Re: **SCI-823-6.81, Portsmouth Bypass Project, PID 19415**
Addendum to Report: Lucasville-Minford Road (CR 28) Interchange
Embankment Stability, Time-Rate of Consolidation, Soil Cut Slope Stability, and Subgrade
Treatment
DLZ Job No.: 0121-3070.03, Document No. 108

DLZ has reviewed ODOT-Office of Geotechnical Engineering's (OGE's) Stage I review comments (dated January 31, 2007) for Phase I of the SCI-823 project. In compliance with the review comments, DLZ has modified the slope stability analyses and time-rate of consolidation calculations for the Lucasville-Minford Road (CR 28) interchange embankments. This document also presents recommendations for soil cut slopes, and subgrade treatment for the interchange mainline roadway and ramp alignments contained within the interchange.

CR 28 Interchange_SR 823 Full Height Embankment - Undrained
SCI-823 Portsmouth Bypass Project, Lucasville-Minford Road Interchange
Analysis Method: bishop simplified

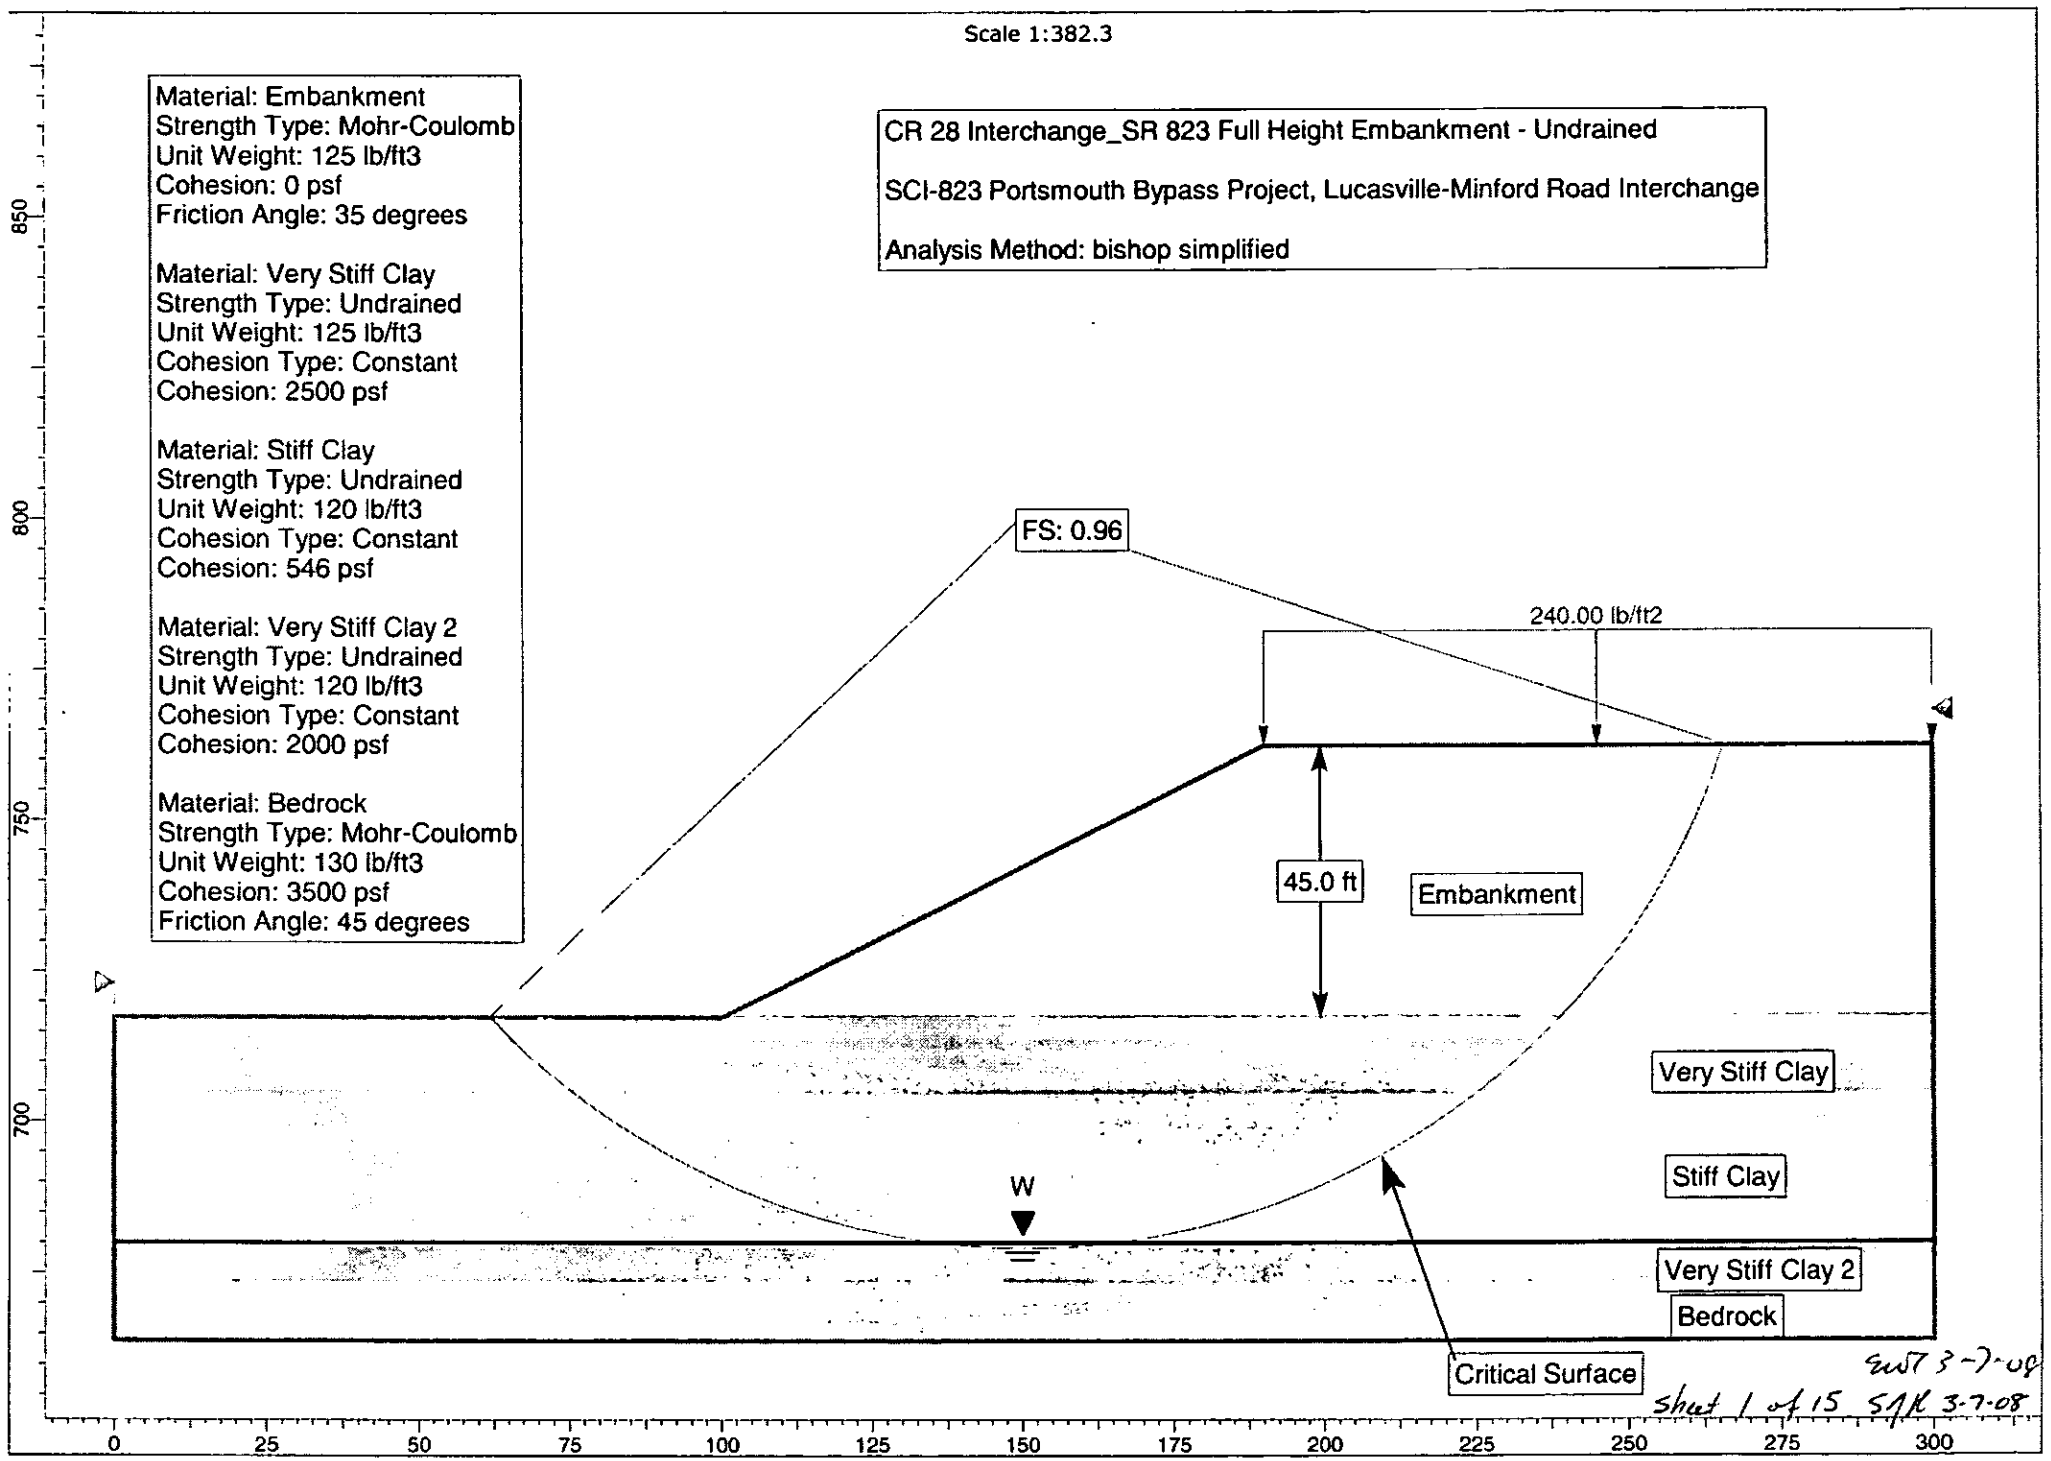
- OGE commented on the minimum required factor of safety against global stability used in the report (FS=1.25). The correct minimum required factor of safety should be 1.30 for the interchange embankments and soil cuts.

Analyses performed for the full height embankment (45 ft) yielded a critical factor of safety of 0.96 for the undrained condition, which is well below the required minimum value of 1.30. Analyses performed for the drained and seismic conditions resulted in infinite slope type failures, with factors of safety of 1.40 and 1.30, respectively. Deeper, specified surfaces also resulted in factors of safety above the minimum required factor of safety of 1.30.

- The global stability of critical embankment sections have been reevaluated using $\phi=35$ degrees and a standard degree of consolidation of ninety percent to report estimated consolidation times. Additionally, the appropriate global stability conditions (undrained and drained) were held to the

CR 28 Interchange_SR 823 Embankment - Stage 1 - Undrained
SCI-823 Portsmouth Bypass Project, Lucasville-Minford Road Interchange
Analysis Method: bishop simplified

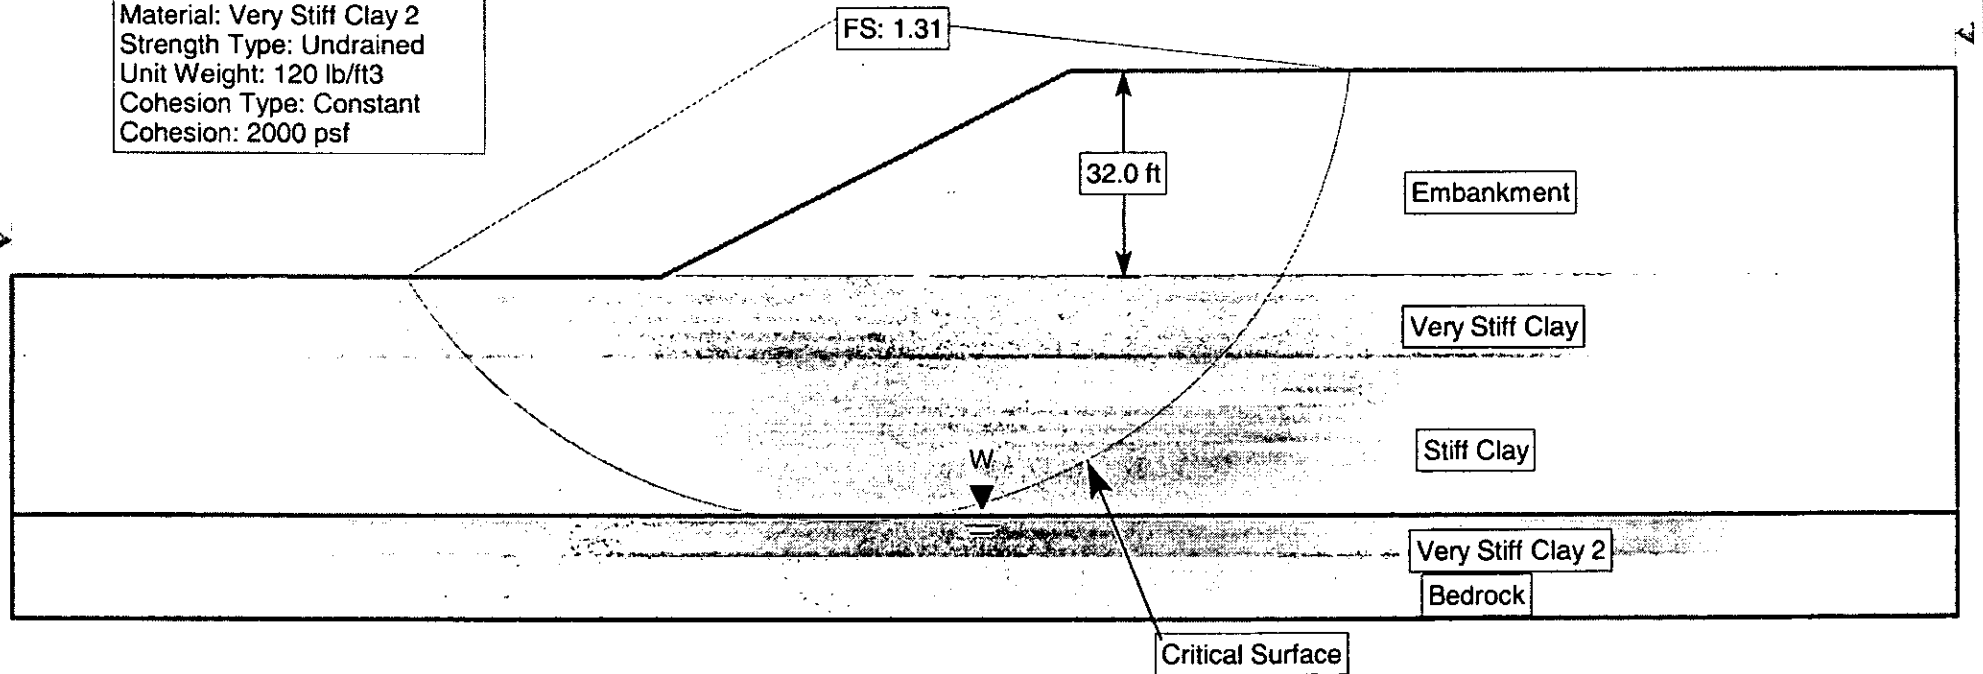
Due to the low in-situ undrained shear strength, construction of the interchange embankments using staged construction was investigated. Analyses indicate that the interchange embankments could be built in two stages. The first embankment stage may be constructed to a maximum height of 32 feet while maintaining the minimum required factor of safety of 1.30. After construction of the stage 1 embankment, a waiting period will be required prior to placing any additional fill. The waiting period is necessary to allow the foundation soil to consolidate under the influence of the stage 1 embankment load. Analyses indicate that at least fifty percent ($U=50\%$) of the excess pore pressures should be allowed to dissipate prior to adding subsequent stages. In addition to the waiting period, the maximum pore water

pressure head during the stage 1 embankment construction should not be greater than 15 feet above the existing ground surface. If the pore pressure rises above this level, the placement of fill should halt immediately to allow the level of the pore pressure to dissipate. The placement of fill may resume after the excess pore pressure has dissipated to a level below 15 feet above the existing ground surface.

CR 28 Interchange_SR 823 Embankment - Stage 2 - Undrained
SCI-823 Portsmouth Bypass Project, Lucasville-Minford Road Interchange
Analysis Method: bishop simplified

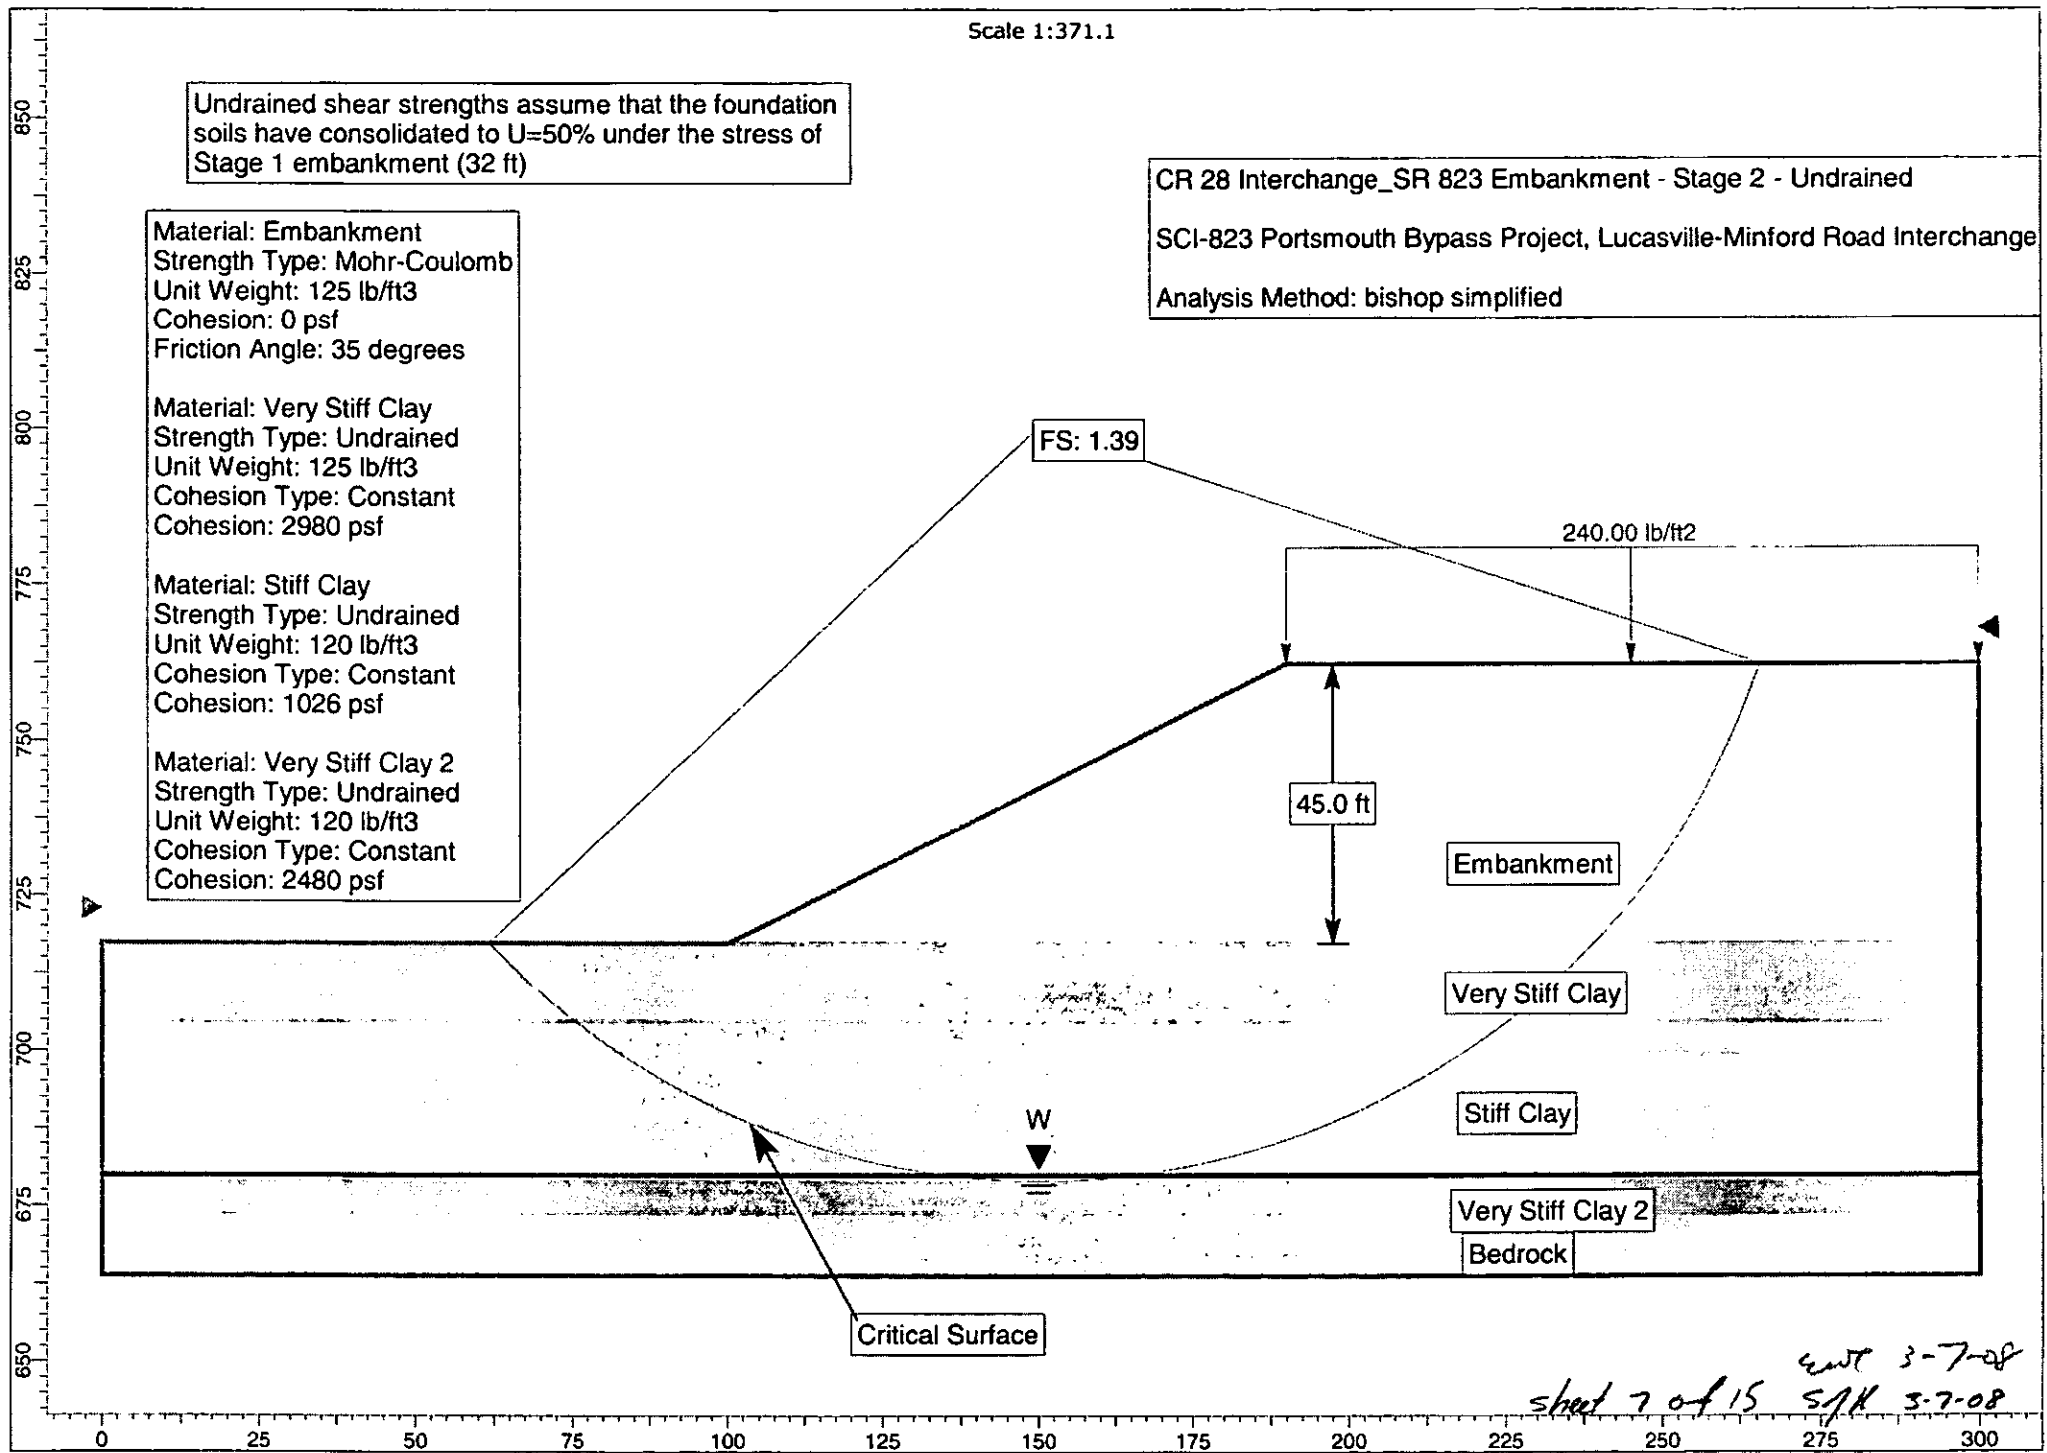
After the consolidation period (U=50%), fill operations for the stage 2 embankment may commence. The stage 2 embankment may be constructed up to the proposed grade level (45 ft). During construction of the stage 2 embankment, the maximum pore water pressure head should not be greater than 10 feet above the existing ground surface. If the pore pressure rises above this level, the placement of fill should halt immediately to allow the level of the pore pressure to dissipate. The placement of fill may resume after the excess pore pressure has dissipated to a level no greater than 10 feet above the existing ground surface. A summary of the analyses, as well as the graphic results of stability analyses are attached.
